Title: Cavalon Magnetometer Re-Positioning		
AG-SB-2020-04-B-EN		Compliance Category: A – MANDATORY B – RECOMMENDED C – OPTIONAL
Applicability		
Aircraft type & model: Cavalon	Affected Serial number(s): All Cavalon fitted with a Garmin G3X glass cockpit	
The maintenance manual to be referenced is this stated or subsequent issue.		As per AutoGyro website
This form is the response from AutoGyro GmbH either against a problem found in the product in service requiring a containment or rectification action, or as service information for aircraft modification incorporation. For help, contact AutoGyro on 49(0)5121 88056-00, or email airworthiness@auto-gyro.com.

Reason and overview of the Service Bulletin (cause of problem if known)

(Pic. 2)

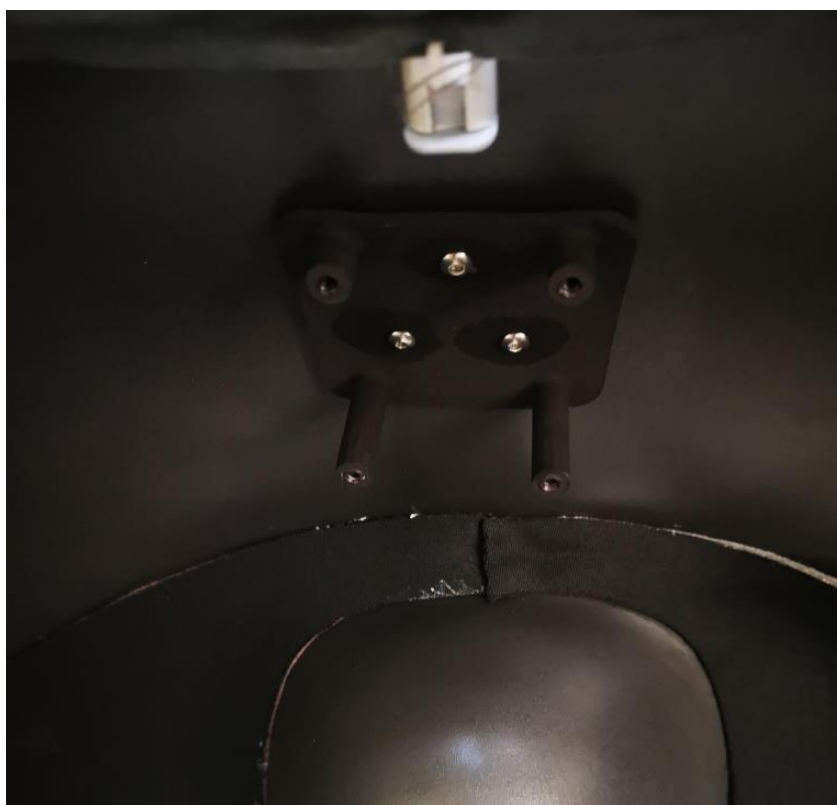
3. Using a suitably adapted 6mm drill (Pic. 2), drill the 3 previously marked holes to M6.
NOTE: ensure that the outer fuselage is not contacted!
4. Countersink the holes and assemble the countersunk rivet nuts in the cabin roof using M4 rivet nut pliers (Pic. 3).

(Pic. 4)

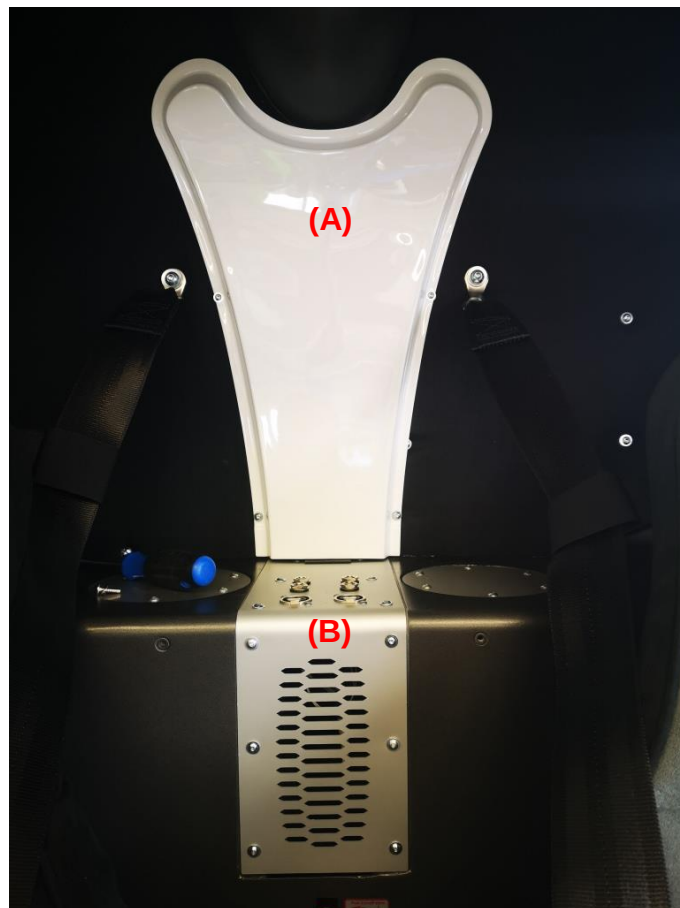
5. Assemble the bracket (47741) to the cabin roof using the 3 x Mx10 A2 screws and Loctite 221 red (30488) (Pic. 4).
6. Remove the throttle/brake center console iaw AMM Job Card 67-10-00 4-1.

(Pic. 6)

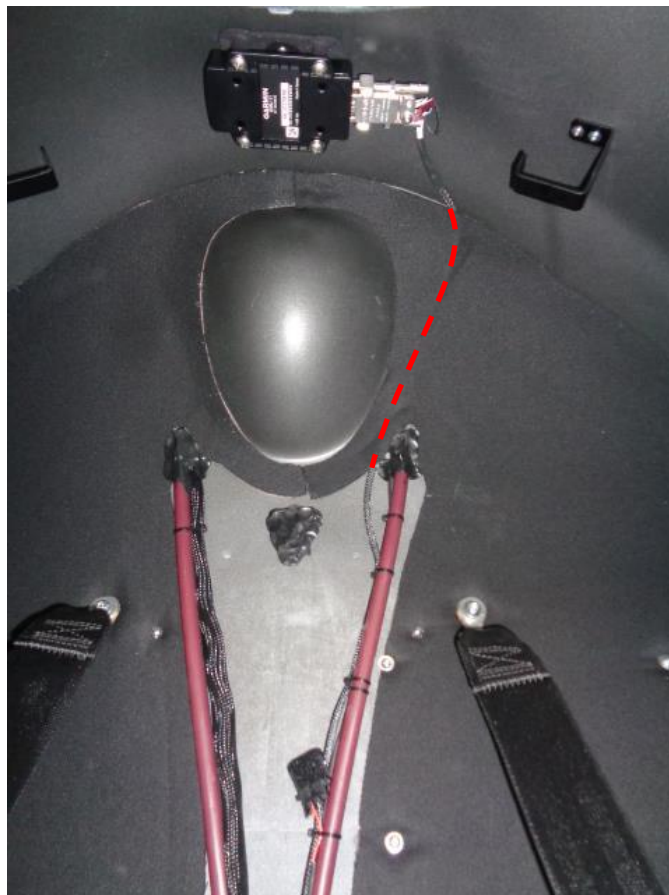
8. Remove the rear bulkhead PPC cover (Pic. 5, item A) & intercom panel (Pic. 5, item B).
9. Screw the 2 connecting nuts onto the Sub D plug from set 47742 (Pic. 6).
